Access Compliance Report

Public Rights-of-Way

Intersection ID: 20035	Main Street: FAIRVIEW_RD	Cross Street: KNOB_OAK_LN	Location: SW
ADA ID: 8A06695D6012	Ramp Type: PerpDiag	Initial Pass/Fail: Fail	Overall Compliance: No
		Severity Score: 12.5

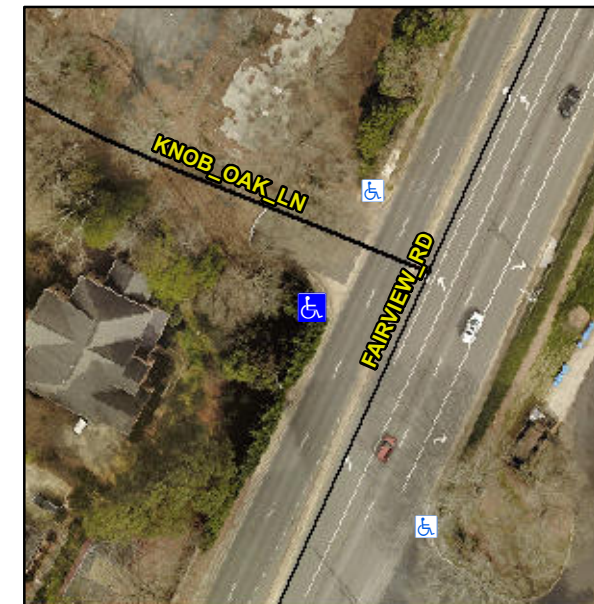
Not Found, R304.5.3

Compliance	Description	Data	Compliance	Description	Data
N/A	Ramp Length (in)	60.0	Yes	Ramp Slope (%)	7.9
Yes	Ramp Width (in)	48.0	No	Ramp XSlope (%)	5.1
N/A	Flare Type LT	N/A	N/A	Flare Type RT	N/A
N/A	Flare Slope LT (%)	N/A	N/A	Flare Slope RT (%)	N/A
N/A	Flare Traversable LT?	N/A	N/A	Flare Traversable RT?	N/A
N/A	Landing Length (in)	N/A	N/A	DWS Provided?	N/A
N/A	Landing Width (in)	N/A	N/A	DWS Contrast?	N/A
N/A	Landing Slope (%)	N/A	N/A	DWS Length (in)	N/A
N/A	Landing X Slope (%)	N/A	N/A	DWS Full Width?	N/A
N/A	Landing Curb? (Y/N)	N/A	N/A	DWS Offset (in)	N/A
N/A	Shared Landing?	N/A			
N/A	Gutter Ponding?	N/A	N/A	Gutter Slope (%)	N/A
N/A	Gutter Lip Ht (in)	N/A	N/A	Gutter X Slope (%)	N/A
N/A	Painted X Walk1?	No	N/A	Painted X Walk2?	No
	X Walk 1 Direction	To SE		X Walk 2 Direction	To NE
N/A	X Walk 1 Width (in)	N/A	N/A	X Walk 2 Width (in)	N/A
	X Walk 1 Slope (%)	3.8		X Walk 2 Slope (%)	0.4
	X Walk 1 X Slope (%)	0.3		X Walk 2 X Slope (%)	4.4

Remove & Replace Curb Ramp With Two New Directional Ramps or Equivalent.
